# Access Compliance Report

## Public Rights-of-Way

Intersection ID: 20840	Main Street: SARDIS_LN	Cross Street: SARDIS_RD	Location: NW
ADA ID: 83520A4BFDCE	Ramp Type: PerpDiag	Initial Pass/Fail: Fail	Overall Compliance: No
		Severity Score: 35

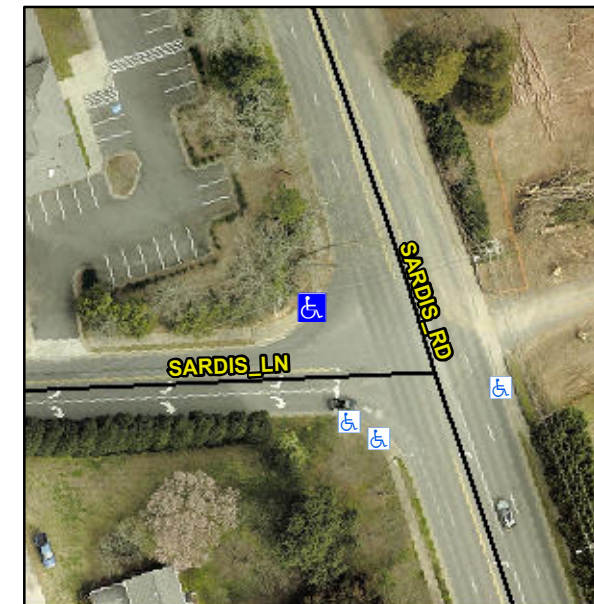
**R304.5.1, R304.2.2, R304.5.3**

Compliance	Description	Data	Compliance	Description	Data
N/A	Ramp Length (in)	60.5	No	Ramp Slope (%)	12.5
No	Ramp Width (in)	44.0	No	Ramp XSlope (%)	2.9
N/A	Flare Type LT	N/A	N/A	Flare Type RT	N/A
N/A	Flare Slope LT (%)	N/A	N/A	Flare Slope RT (%)	N/A
N/A	Flare Traversable LT?	N/A	N/A	Flare Traversable RT?	N/A
N/A	Landing Length (in)	N/A	N/A	DWS Provided?	N/A
N/A	Landing Width (in)	N/A	N/A	DWS Contrast?	N/A
N/A	Landing Slope (%)	N/A	N/A	DWS Length (in)	N/A
N/A	Landing X Slope (%)	N/A	N/A	DWS Full Width?	N/A
N/A	Landing Curb? (Y/N)	N/A	N/A	DWS Offset (in)	N/A
N/A	Shared Landing?	N/A			
N/A	Gutter Ponding?	N/A	N/A	Gutter Slope (%)	N/A
N/A	Gutter Lip Ht (in)	N/A	N/A	Gutter X Slope (%)	N/A
N/A	Painted X Walk1?	No	N/A	Painted X Walk2?	No
	X Walk 1 Direction	To S		X Walk 2 Direction	To E
N/A	X Walk 1 Width (in)	N/A	N/A	X Walk 2 Width (in)	N/A
	X Walk 1 Slope (%)	2.8		X Walk 2 Slope (%)	4.2
	X Walk 1 X Slope (%)	3.5		X Walk 2 X Slope (%)	0.6

**Remove & Replace Curb Ramp With Two New Directional Ramps or Equivalent.**
